3GPP TSG RAN WG1 ***TSGR1#15(00)1042***
Berlin, Germany, 22nd – 25th August, 2000

Title: **Corrections to TS25.212**

25.212	**CR**	**087**		Current Version:	3.3.0

Subject: Corrections

Figure 10: Channel coding of split mode TFCI information bits

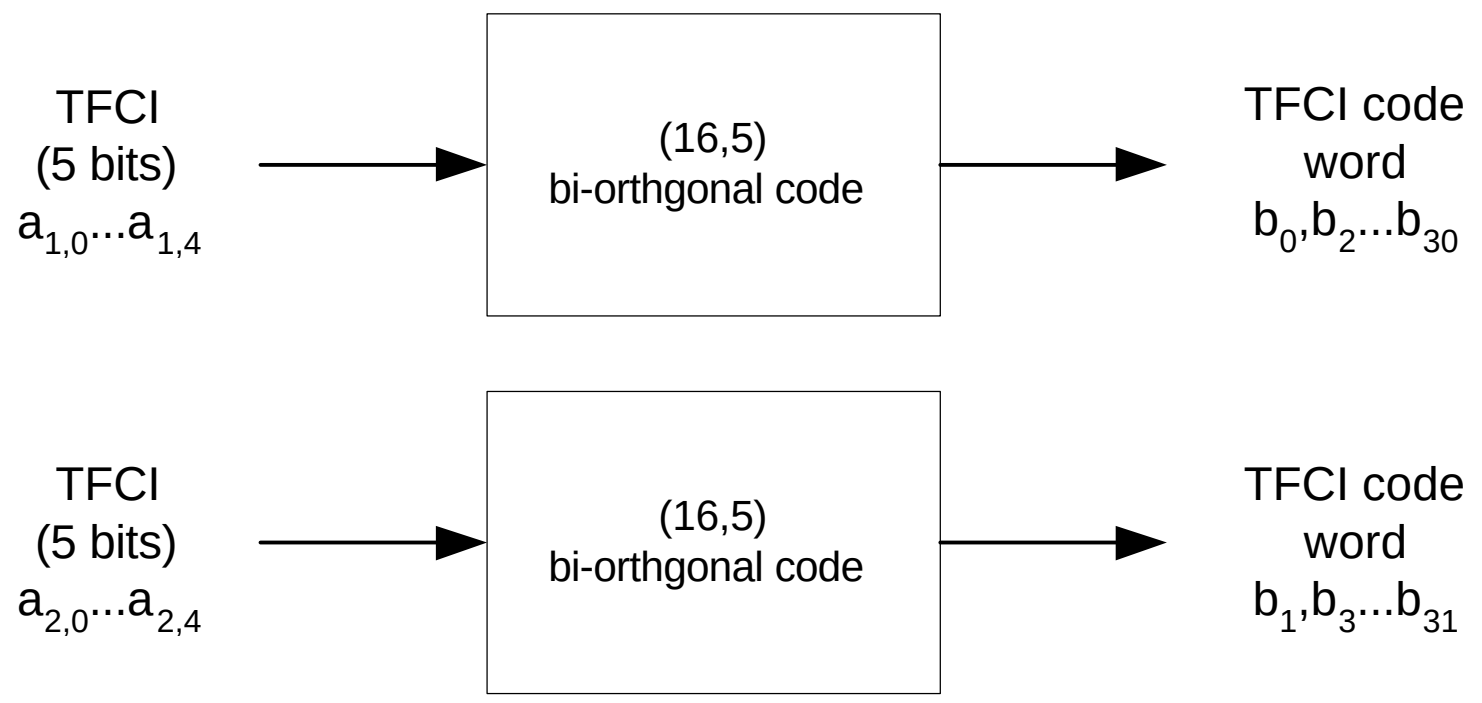
~~Let's define a~~The first set of TFCI information bits ~~as (~~$a_{1,0}$, $a_{1,1}$, $a_{1,2}$, $a_{1,3}$, $a_{1,4}$ ~~(~~where $a_{1,0}$ is LSB and $a_{1,4}$ is MSB~~). This set of TFCI information bits~~ shall correspond to the TFC index (expressed in unsigned binary form) defined by the RRC layer to reference the TFC of the DCH CCTrCH in the associated DPCH radio frame.

~~Let's define a~~The second set of TFCI information bits ~~as~~ ($a_{2,0}$, $a_{2,1}$, $a_{2,2}$, $a_{2,3}$, $a_{2,4}$ (where $a_{2,0}$ is LSB and $a_{2,4}$ is MSB)~~.~~ ~~This set of TFCI information bits~~ shall correspond to the TFC index (expressed in unsigned binary form) defined by the RRC layer to reference the TFC of the associated DSCH CCTrCH in the corresponding PDSCH radio frame.
